**TECHNICAL MANUAL**  
**FOR**  
**RADIO RECEIVER R-390A/URR**  
**VOLUME I OF III**

6-R390A/URR

INTERNAL HEAT REDUCTION  
FSN N5820-937-0141

TEMPORARY CHANGE T-4 to TECHNICAL MANUAL for Radio Receiver R-390A/URR NAVSHIPS 0967-063-2010 (formerly NAVSHIPS 93053).

Figure 1. Correction to figure 89-1.

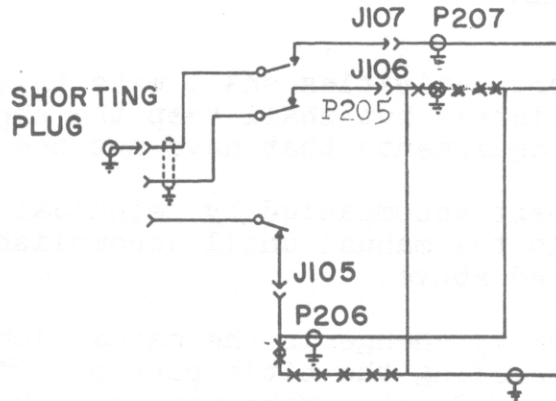
f. Page 178, figure 89-1:

(1) Correct antenna input connections at upper left side of page as shown in figure 1 of this article.

(2) Delete "125 ohm Balanced" in J104 block at left of antenna input.

(3) Below antenna input wiring, write "Antenna input modified on shipboard installations by Field Change 5. Shipboard installations use J103."

FIGURE 89 (2) --- NAVSHIPS 93053

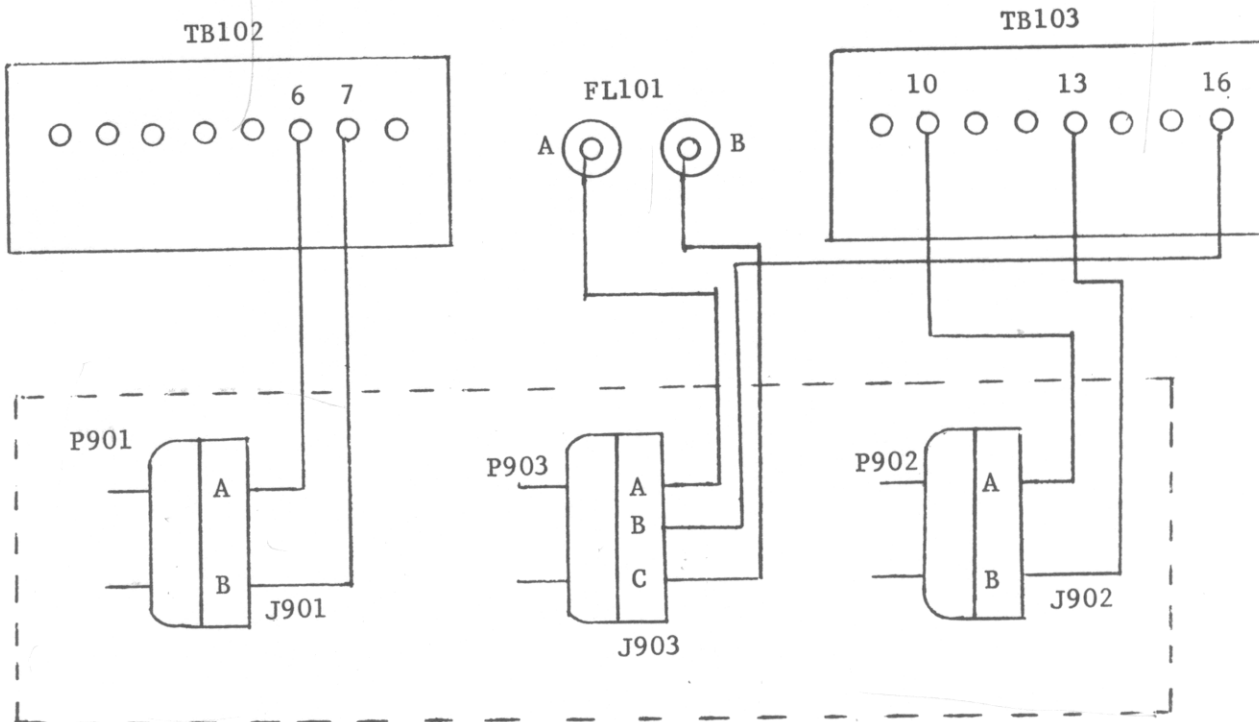
Figure 89, sheet 2: Delete wire between P120-11 and shielded ground 1/4 inch above P120-11. Change shielded ground connection into a test jack and at right, label "J904-Diode Load Test Jack."

126	Figure 75	Delete "16 GND" and add: "Ground common lead of electronic multimeter at any convenient point on the receiver."
130	Figure 76	Add: "Connections to terminal boards TB102 and TB103 must be made from inside the receiver."
134	Figure 77	Same as Figure 76.
140	Figure 79	Same as Figure 76.
142	Figure 80	Same as Figure 76.
178	Figure 89 (Sheet 1)	Change Fig. 89, sheet 1, to show AC input power in accordance with Figure 1 center drawing of T-1(A) NAVSHIPS 93053.
179	Figure 89	Change Fig. 89, sheet 2, to show audio output in accordance with Fig. 1 of T-1(A) NAVSHIPS 93053.

SUPPLEMENTAL SCHEMATIC DIAGRAM  
 FIGURE 89 (2) — NAVSHIPS 93053

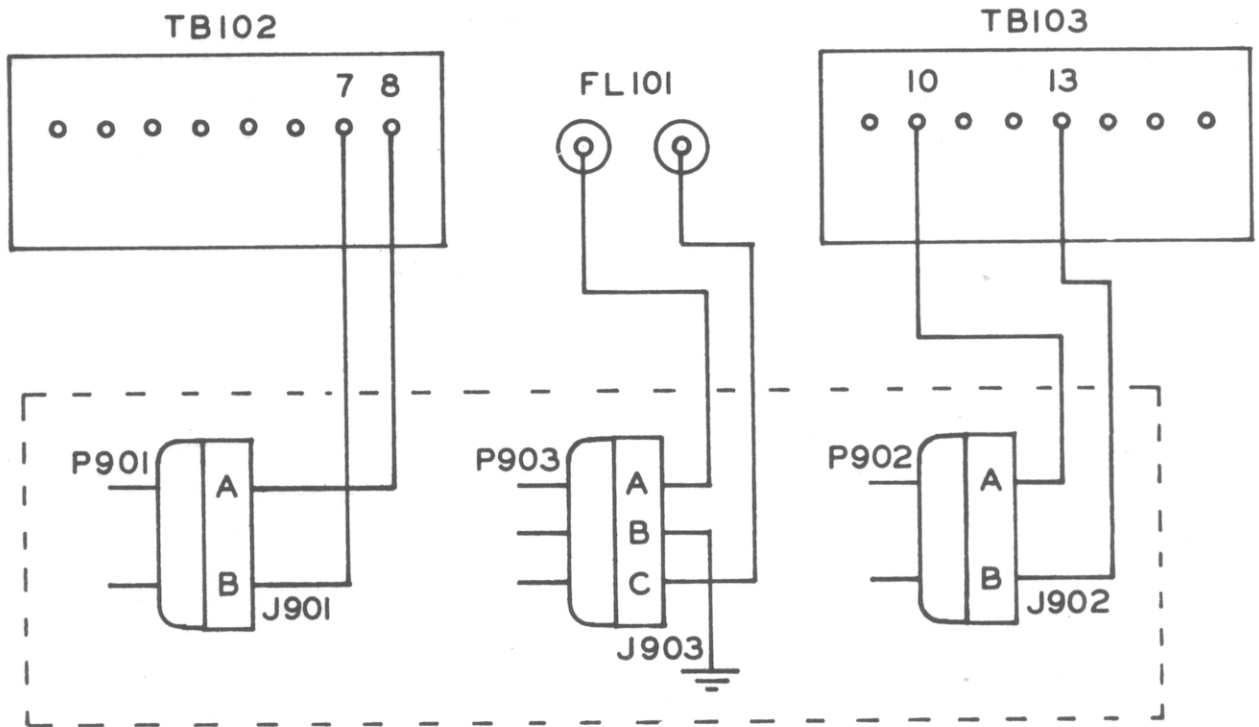
<u>PAGE NO</u>	<u>PARA &amp; LINE or FIG &amp; LOCATION</u>	<u>ACTION</u>
12, 14, 15	Figure 7	Delete illustrations 8 to 19 inclusive
13	WARNING	Change: "...connect GND terminal 16 on the rear panel to the same ground as the power source." to: "...be sure that the receiver is grounded to the same source as the AC power."
21	15 (e) Step 2	Delete: "Loudspeaker connected to LOCAL AUDIO terminals 6 and 7, or..."
	Step 3	Add after 13: "via P902 and J902."  Delete: "If 600 ohm line is not available, connect headset to terminals for test purposes."
Volume III		
126	Figure 75	Delete "16 GND" and add: "Ground common lead at any convenient point on the receiver."
130	Figure 76	Add: "Connections to terminal strips TB102 and TB103 must be made from inside the receiver."
134	Figure 77	Same as Figure 76.
140	Figure 79	Same as Figure 76.
142	Figure 80	Same as Figure 76.
179	Figure 89 (Sheet 2)	Add: "For wiring of connector channel on back panel of receiver, see Figure 1 of this correction.  It is recommended that Figure 1 be inserted between Figure 89(1) and Figure 89(2)."
